ADDENDUM NO. 1

PROJECT NO: 1110169

TITLE OF PROJECT: Visitor Center Repairs and HQ Restroom Replacement

FACILITY LOCATION: Monahans Sandhills State Park

Monahans Sandhills State Park
 Visitors Center & Section House Renovations
 1110169

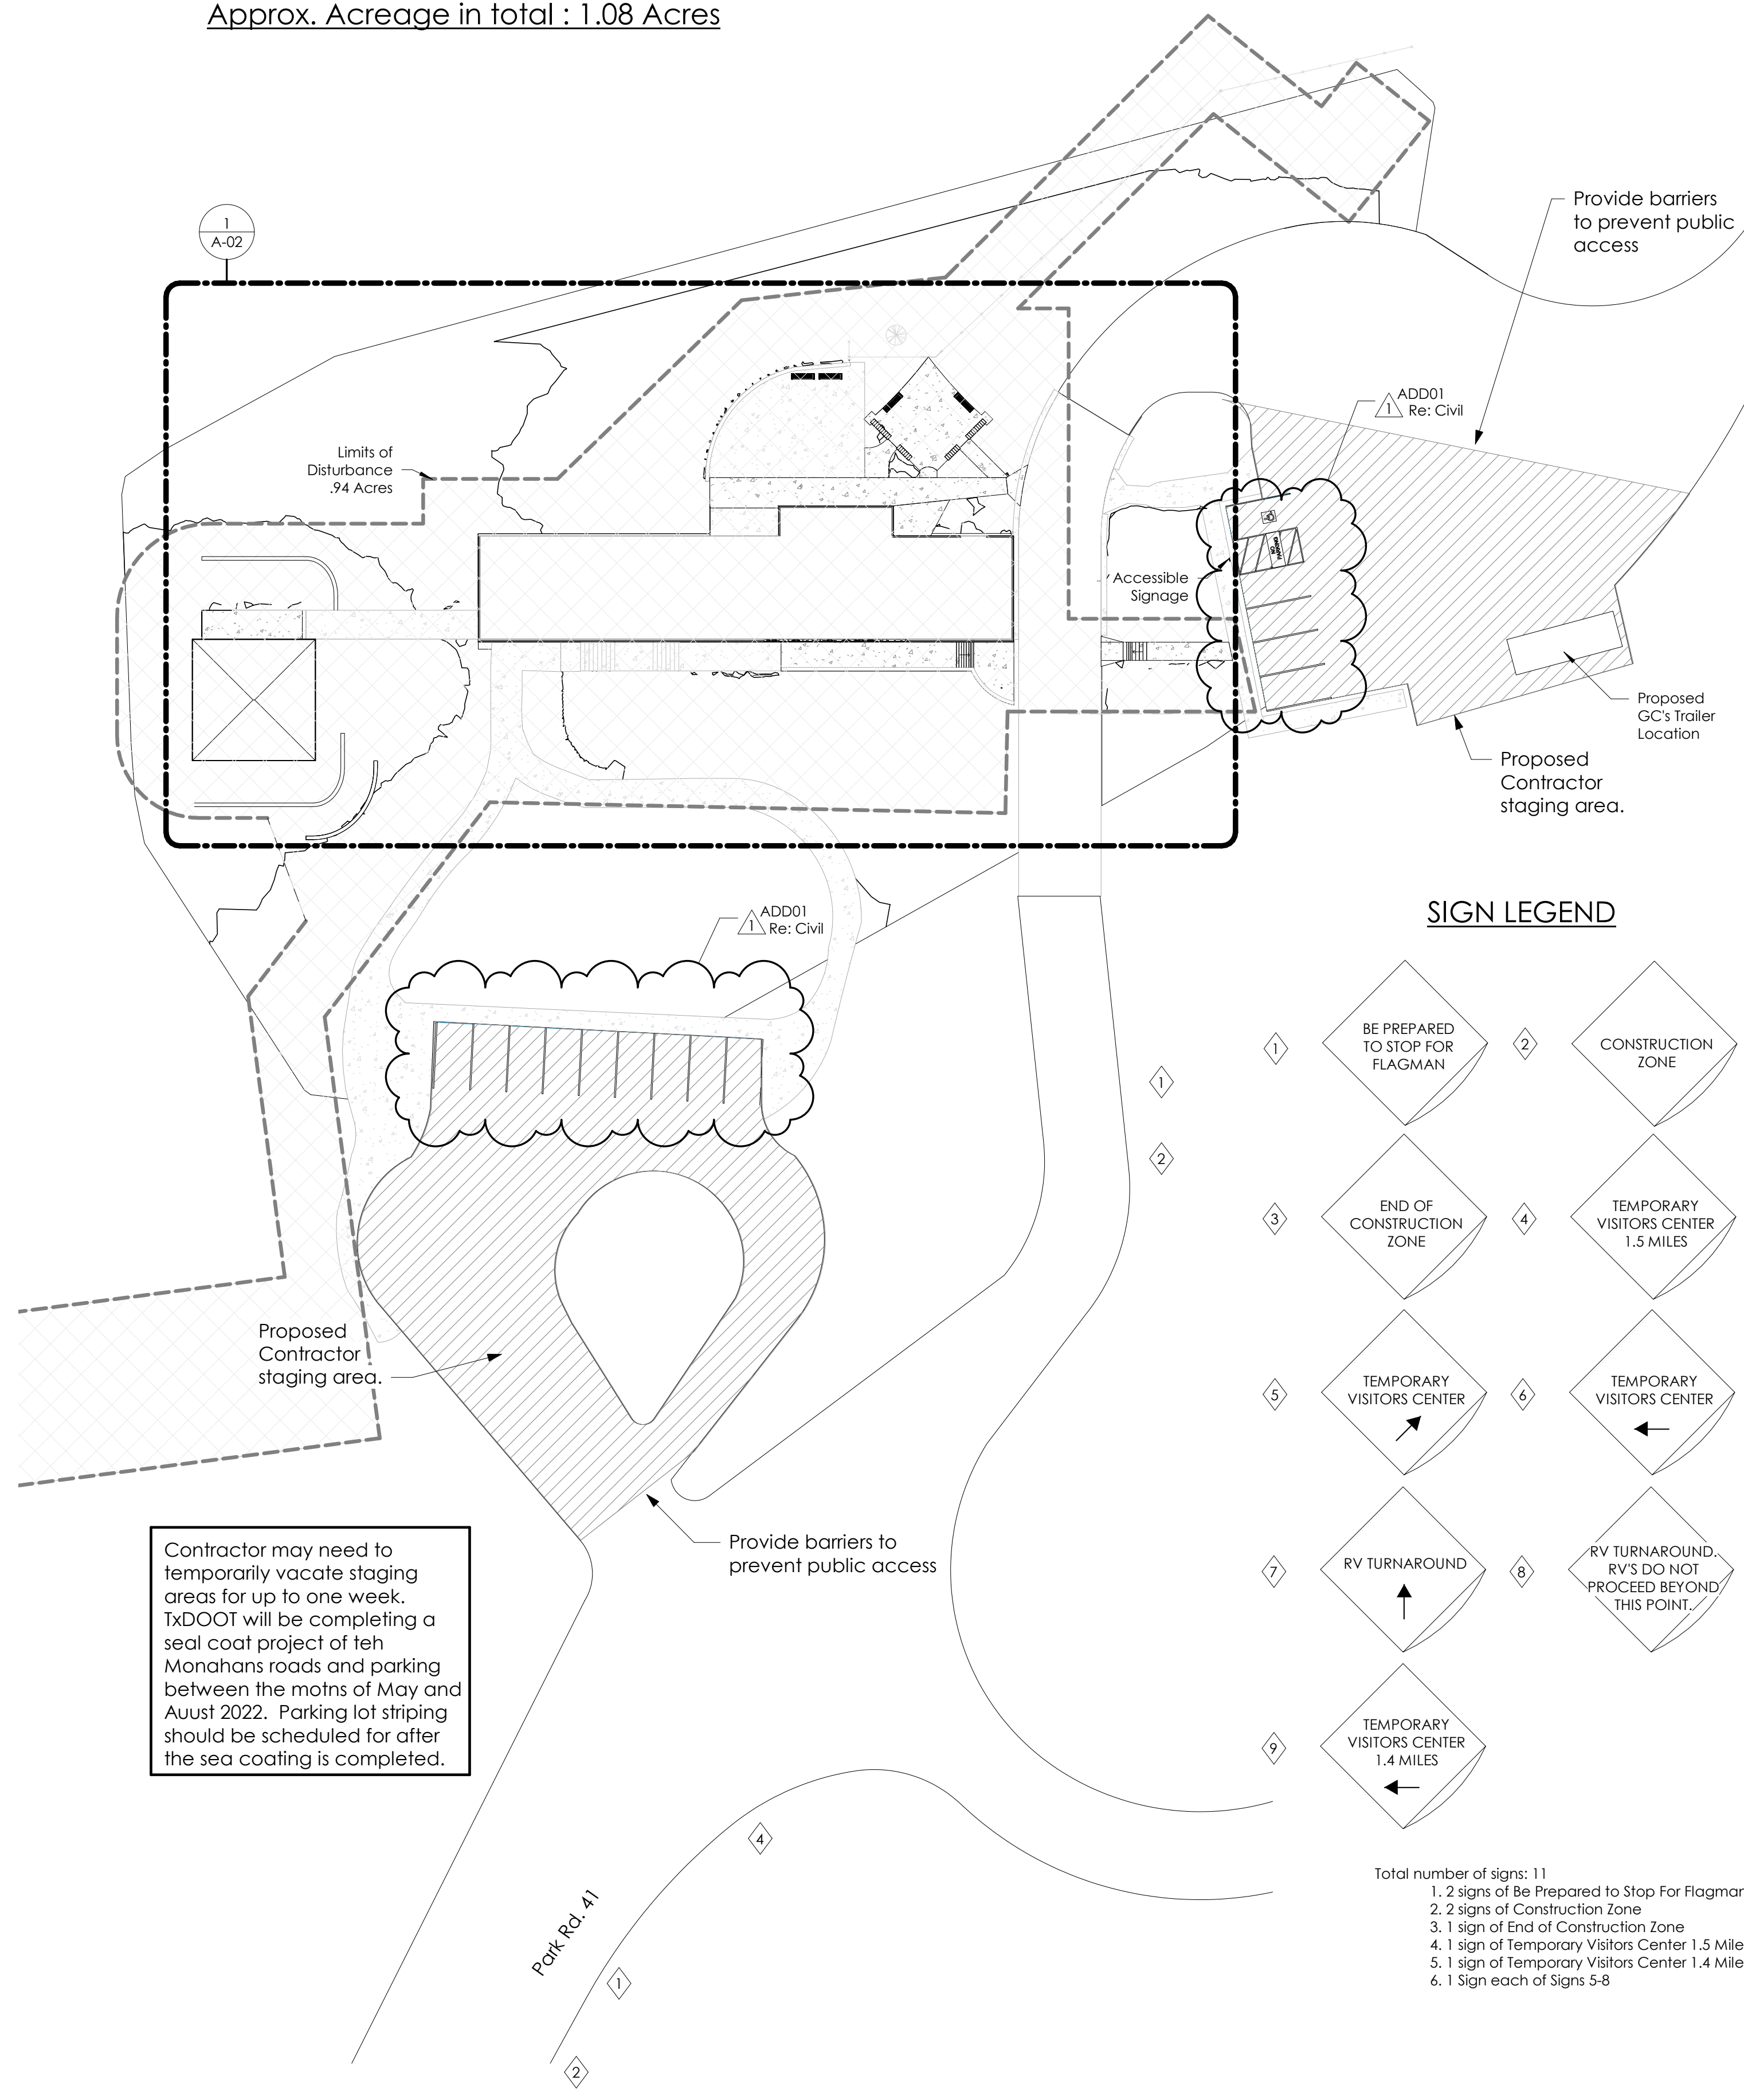
DATE: 03/19/2021
 DESIGNED BY: J.D.Z.
 DRAWN BY: J.D.Z.
 REVIEWED BY: C.C.
 REVISED:
 ADD 1 5/07/21
 SIDEWALK WAS STRAIGHTEN GRADES REVISED TO MEET ADA REQ.

SHEET NUMBER
A-17

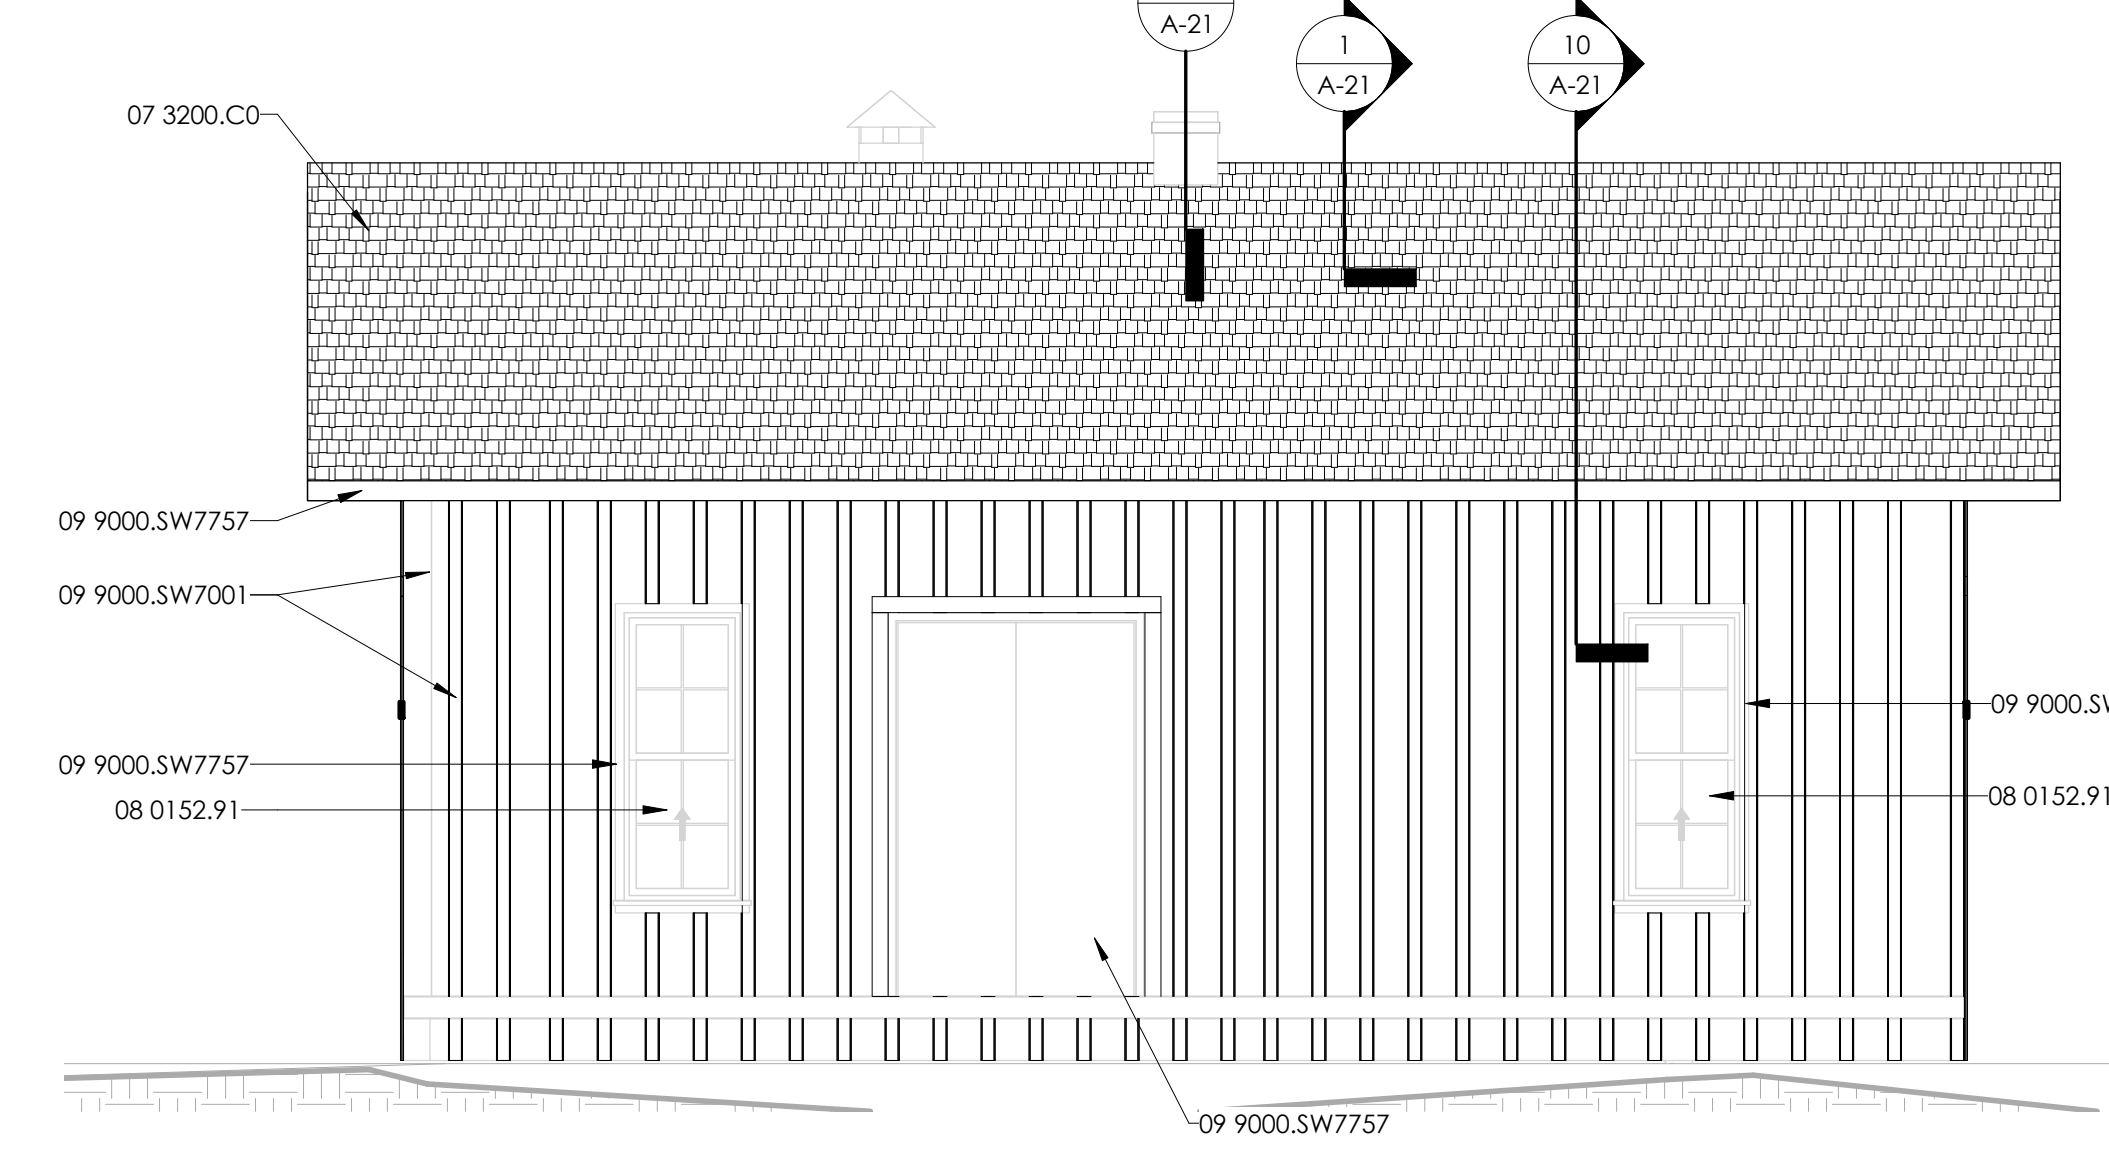
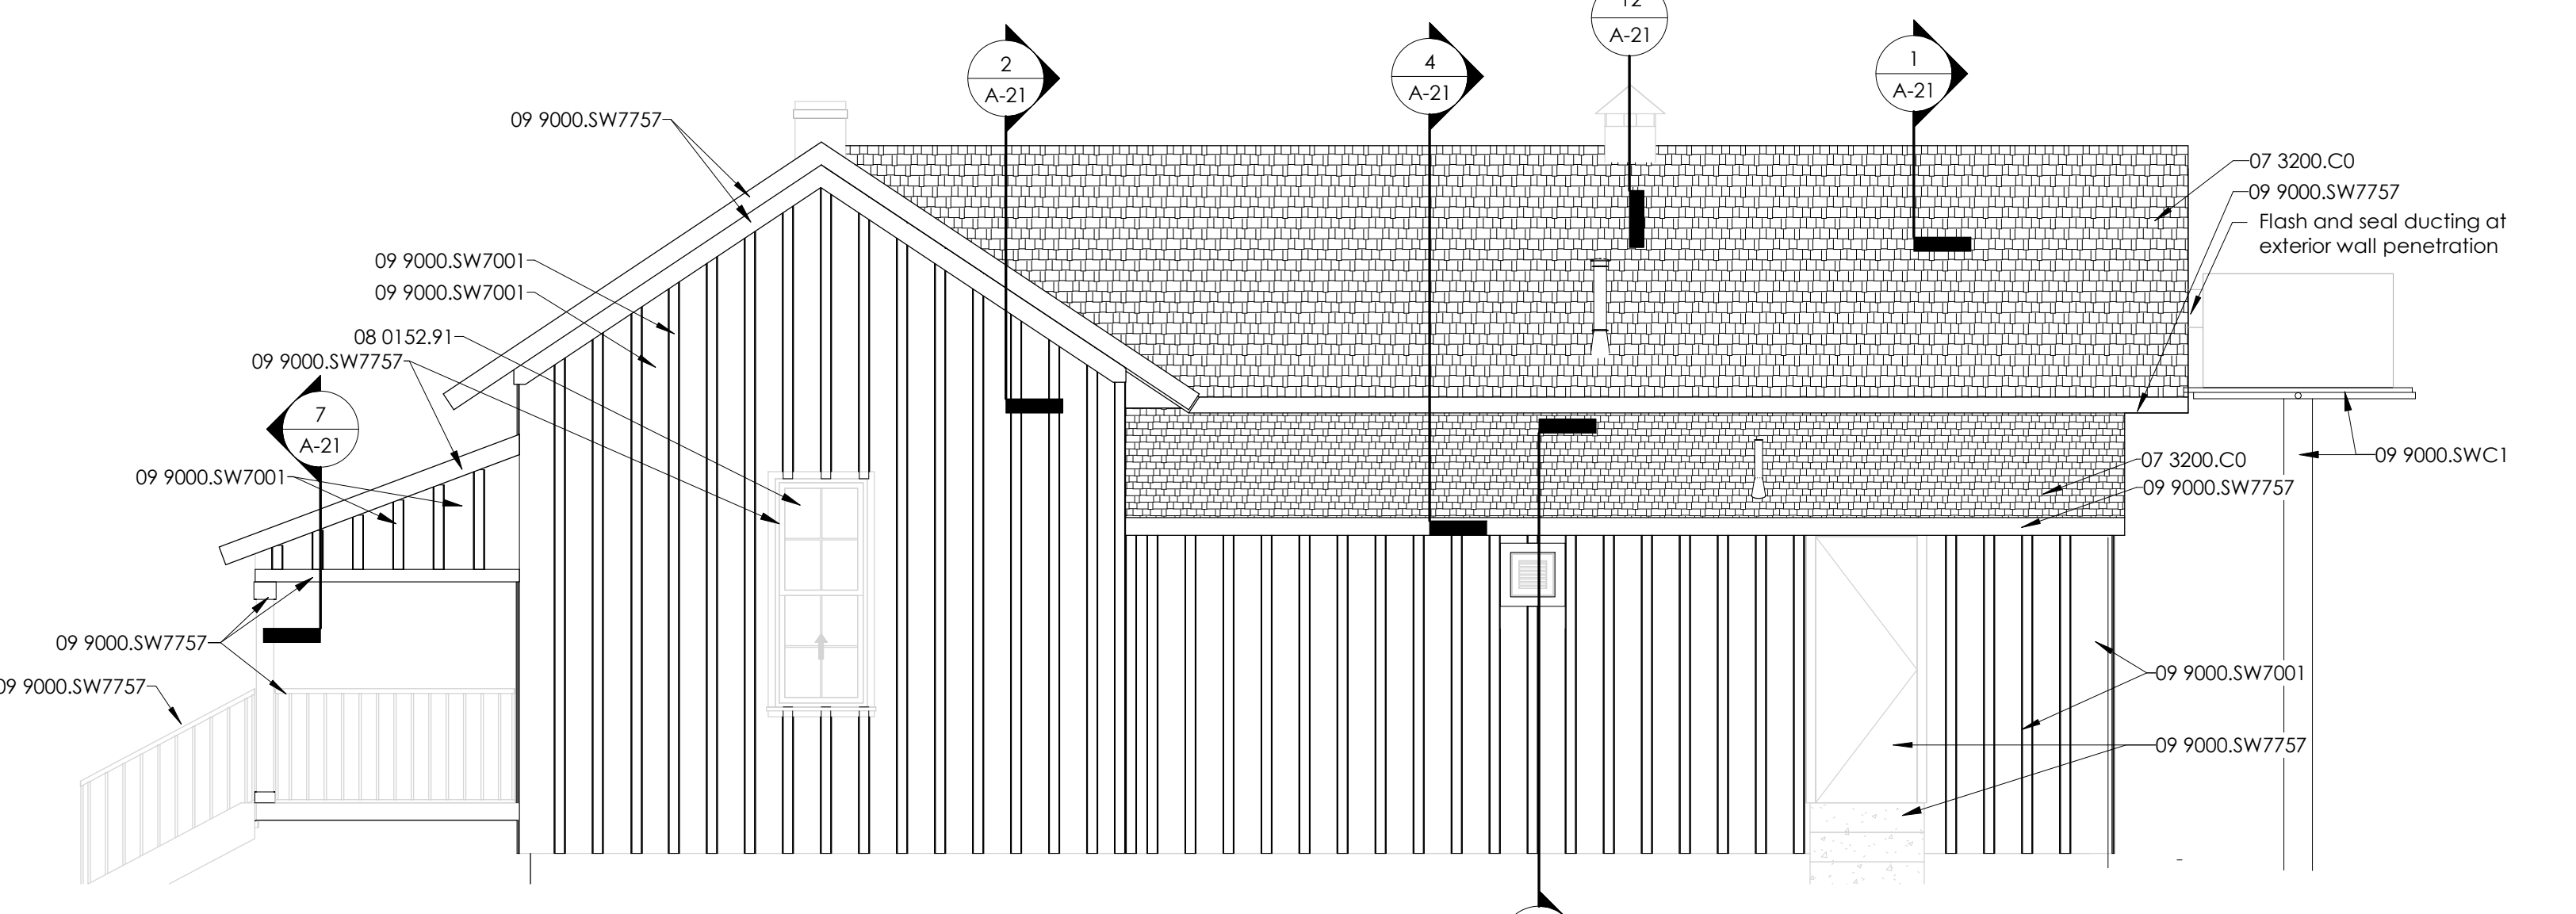
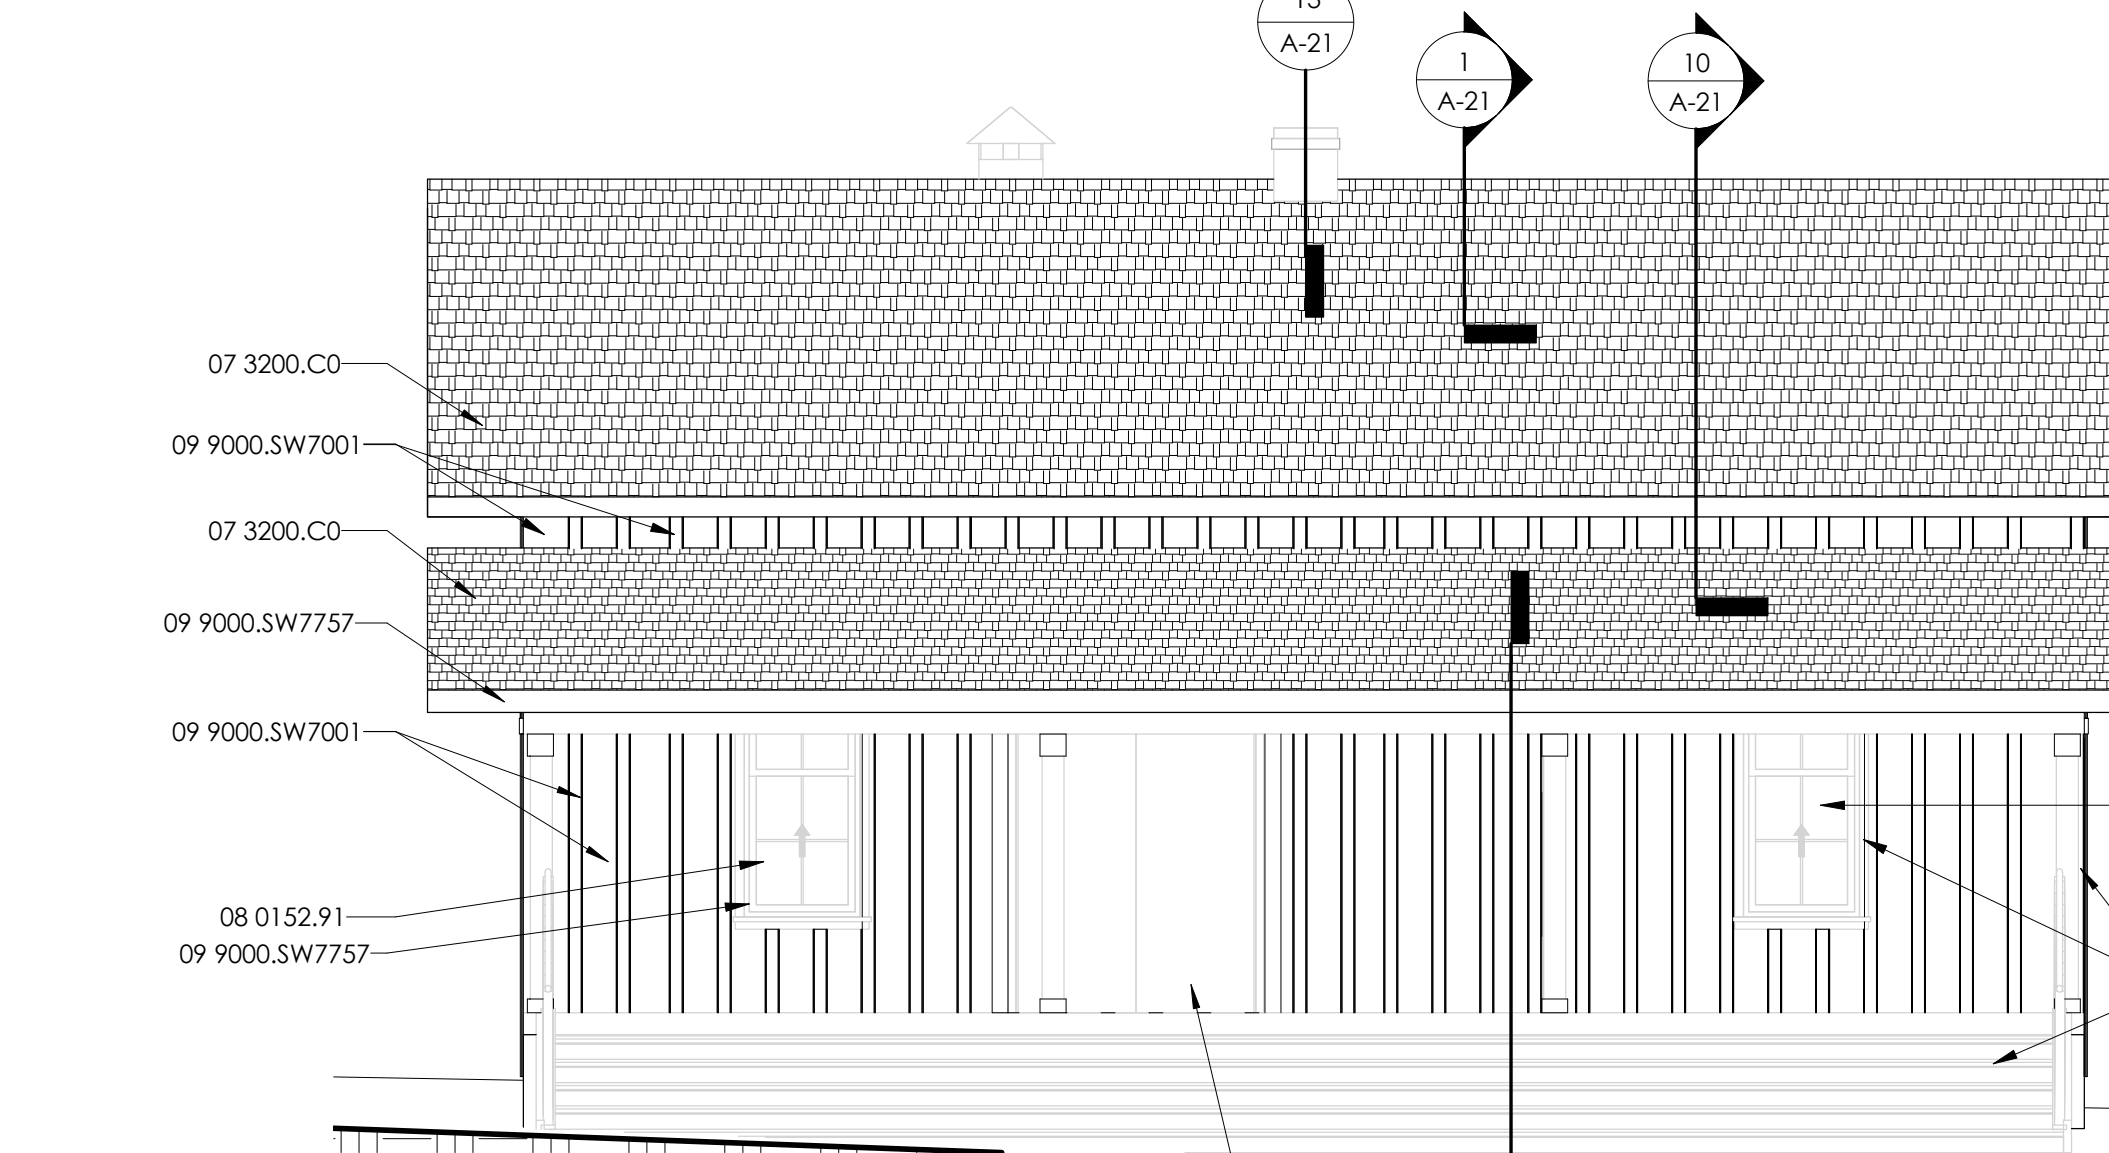
Q: Will the exterior electrical that is surfaced mounted need to be addressed on how to bid?
Please see attached photos

- Surface mounted conduit and boxes that are currently painted the sand color is to be painted color to match surface to which it is attached or nearest surface (e.g. conduit run along underside of porch paint to match soffit/rafter color)

- For exterior electrical outlets where the exterior enclosure has been painted sand, paint the enclosure to match surface to which it is attached. Mask off outlet.

- For wall mounted light fixtures, mask off fixture.
- For under soffit light fixtures at porch, remove light fixtures prior to painting and reinstall after painting complete.
